<b>Docket Number:</b>	17-BSTD-02
<b>Project Title:</b>	2019 Title 24, Part 6, Building Energy Efficiency Standards Rulemaking
<b>TN #:</b>	222594
<b>Document Title:</b>	NAIMA Comments
<b>Description:</b>	Title 24, Part 6
<b>Filer:</b>	Curt Rich
<b>Organization:</b>	North American Insulation Manufacturers Association
<b>Submitter Role:</b>	Public
<b>Submission Date:</b>	2/20/2018 7:30:55 AM
<b>Docketed Date:</b>	2/20/2018

**Subject: Comments from the North American Insulation Manufacturers Association on Docket Number 17-BSTD-02 2019: Title 24, Part 6, Building Energy Efficiency Standards Rulemaking**

*Figure 1 – Limits of acceptable flange & inset batt installation*

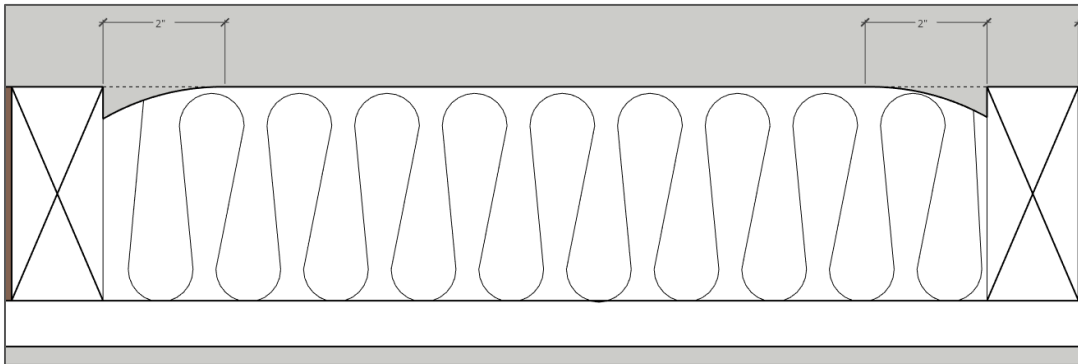
The language in this section could be improved for clarity (suggested text included below). However, NAIMA believes that the inclusion of diagrams that describe these requirements are instructive and provide the most clarity regardless of any changes to the text.

Figure 1 displays the requirement that the batt only be compressed within 2 inches of the side of the stud. The inclusion of such a graphic would clearly show the intent of the requirement and leave no room for confusion or error. Figure 2 shows an inset batt that has both acceptable compression at the side of the stud (less than 2 inches) and extends out of the cavity, which is also acceptable.

“Where batt insulation with flanges that are inset stapled to the side of the stud, the surface of the batt facing the occupied space must be flush with the face of the cavity (or protrude beyond), except the portions of the batt that are less than two inches from the side edge of the stud. Portions of the batt are permitted to protrude beyond the face of the cavity.”
